**Municipal Planning Commission**  
**Regular Meeting**

**Minutes**

**January 12, 2023**  
**4:00 PM**

- 2023-MPC-01 : Liberty Crossing Newark RD, Parcel #66-00501.000 - Comprehensive Development Plan

# THE VILLAGE AT COLONIAL WOODS

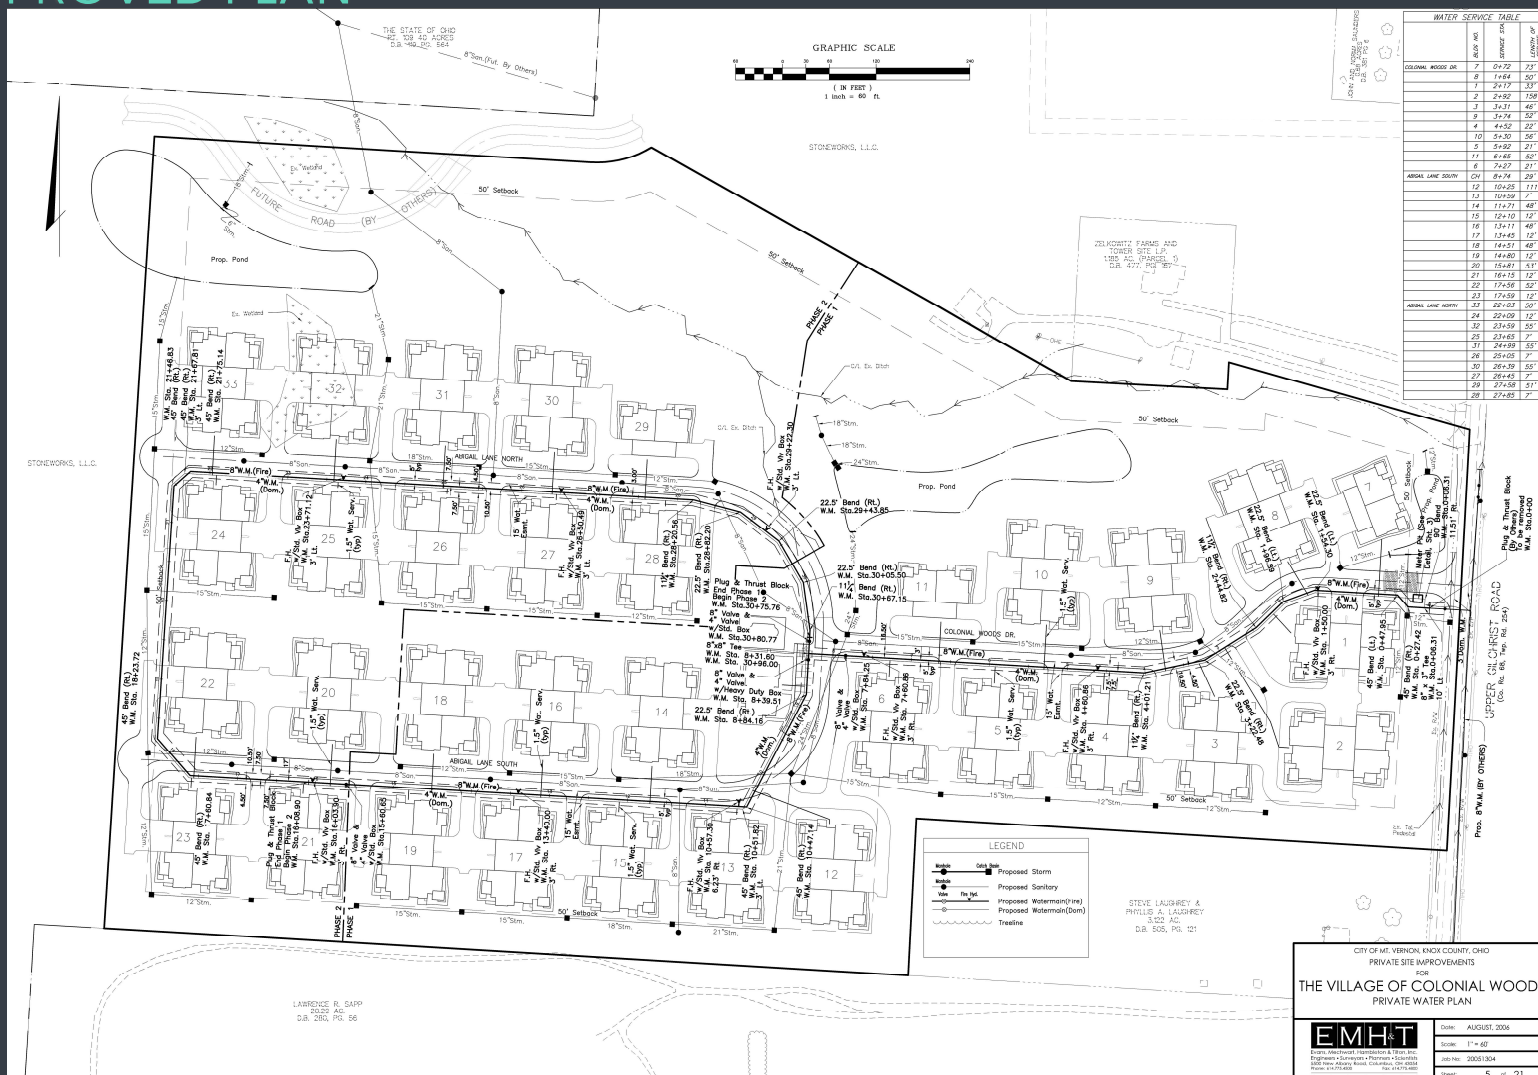
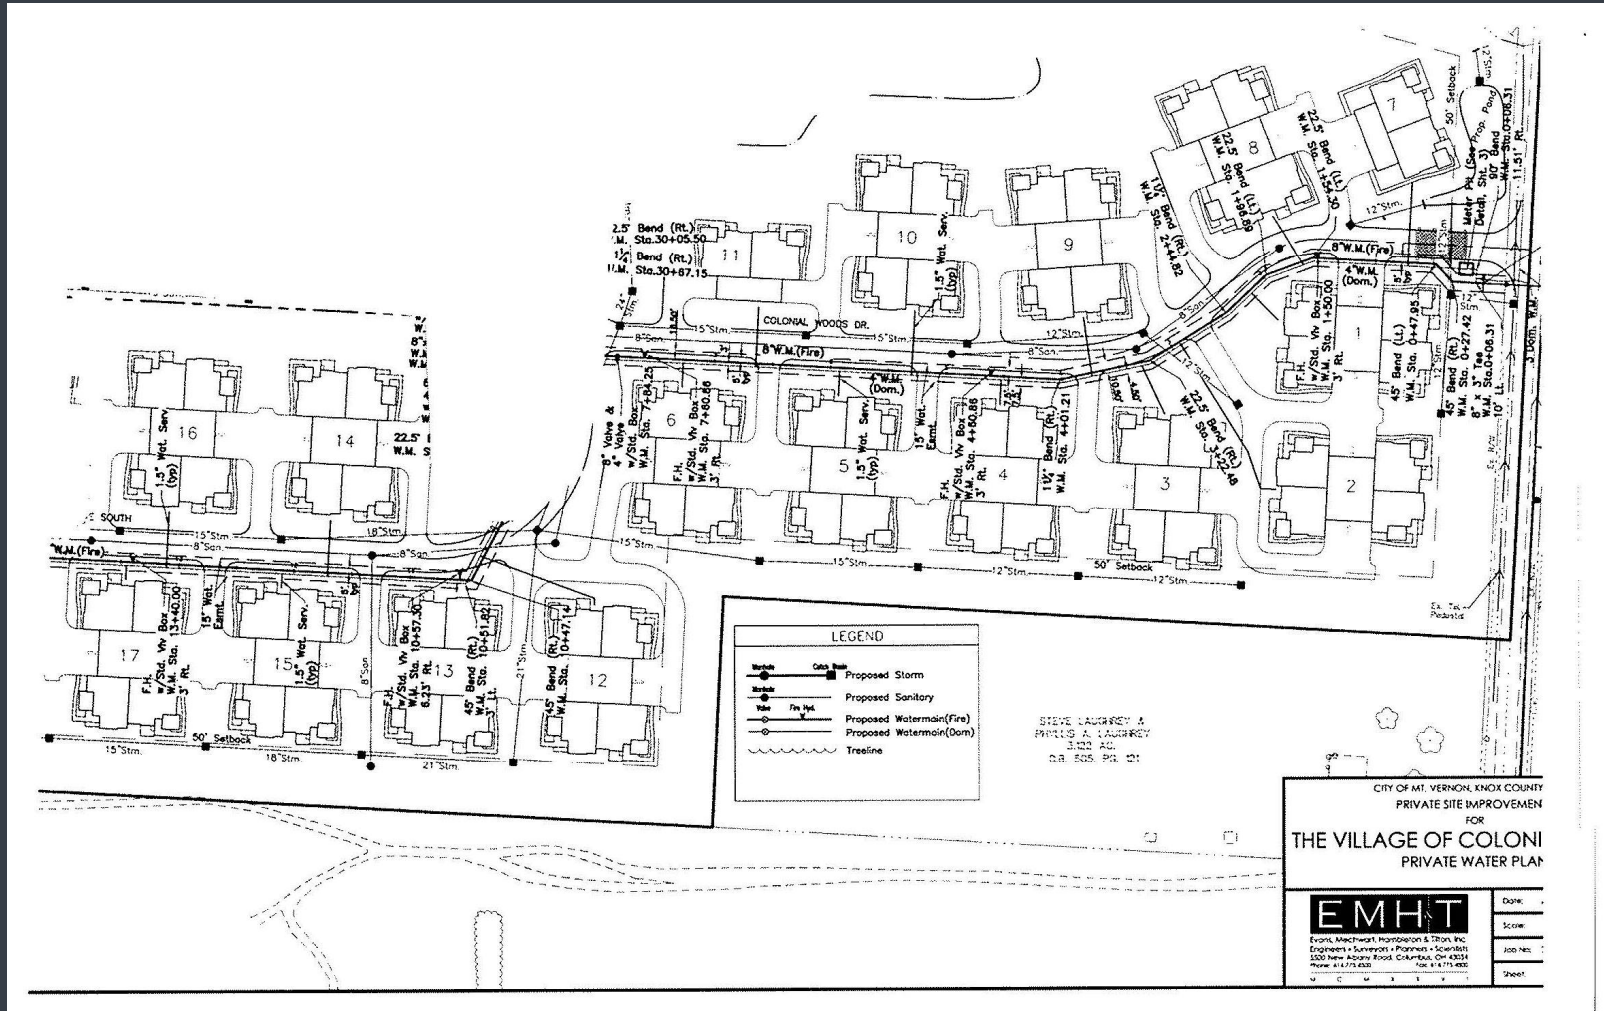
# APPROVED PLAN

# PROPOSED MODIFICATION

## THESE CHANGES SHOULD BE CONSIDERED MINOR MODIFICATIONS

- NO CHANGES ARE BEING MADE TO THE PLAN BEYOND THE SCOPE OF THE DEVELOPMENT, WHICH IS SHRINKING
- THE LOCATION AND SPECS FOR EVERY BUILDING IS REMAINING THE SAME

ORIGINAL PLAN

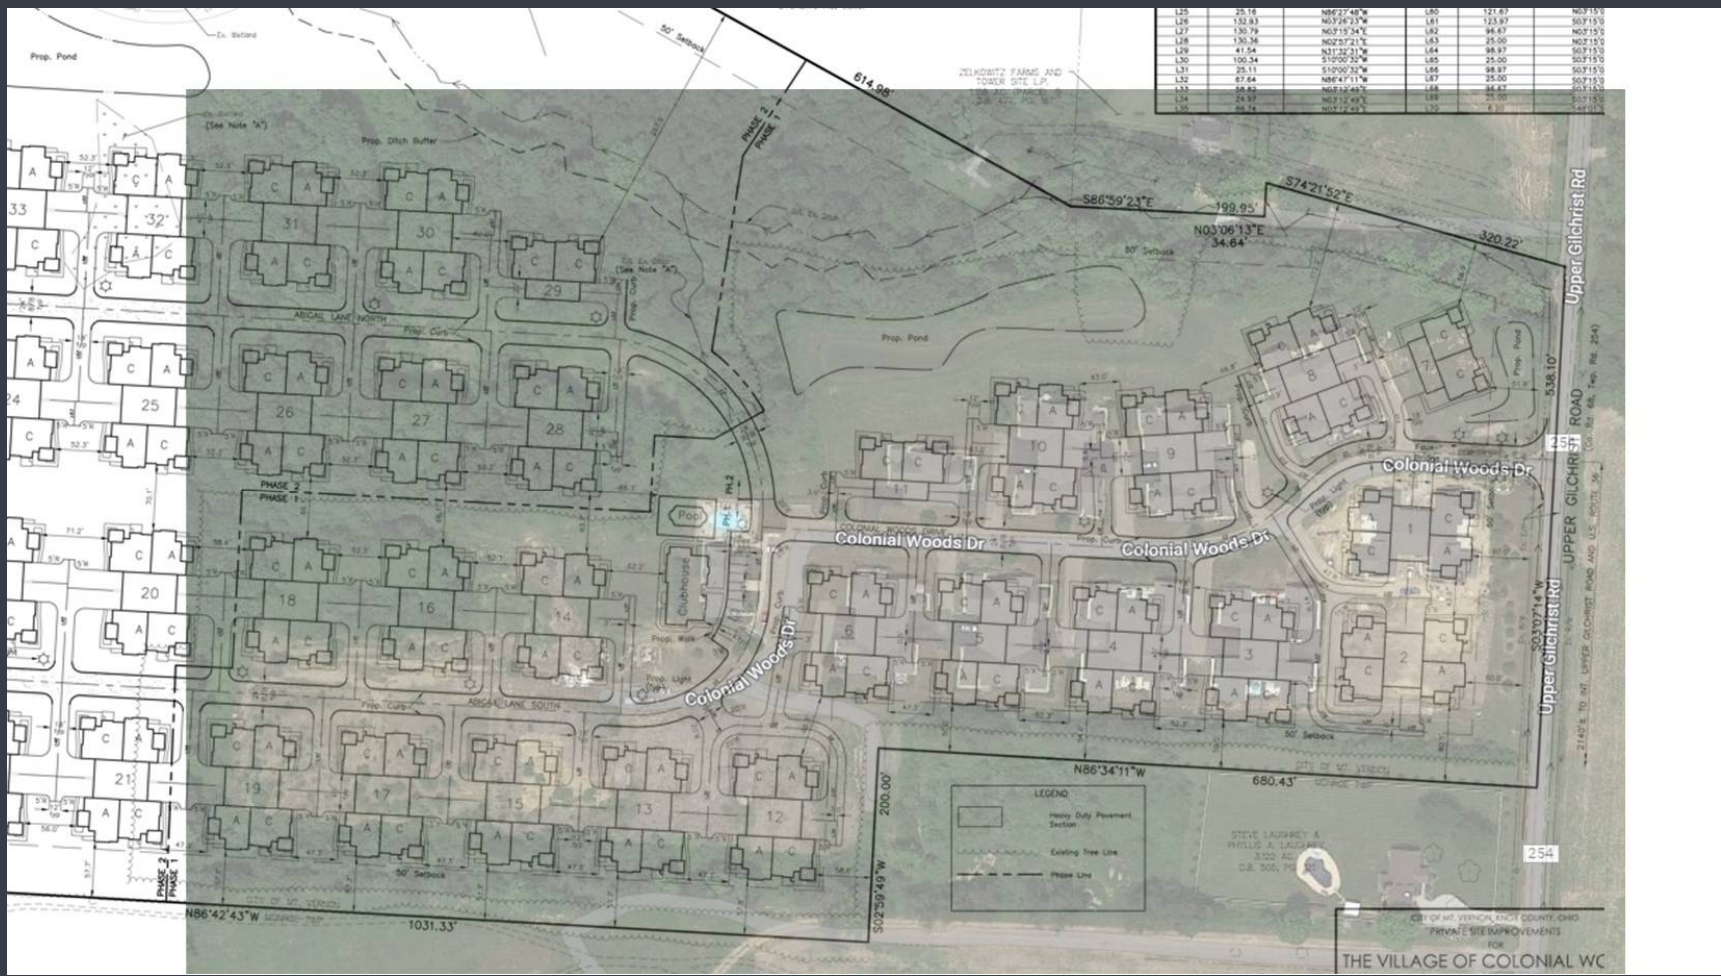
This section of road had about 3' of fill.

## PLAN WITH MINOR MODIFICATIONS
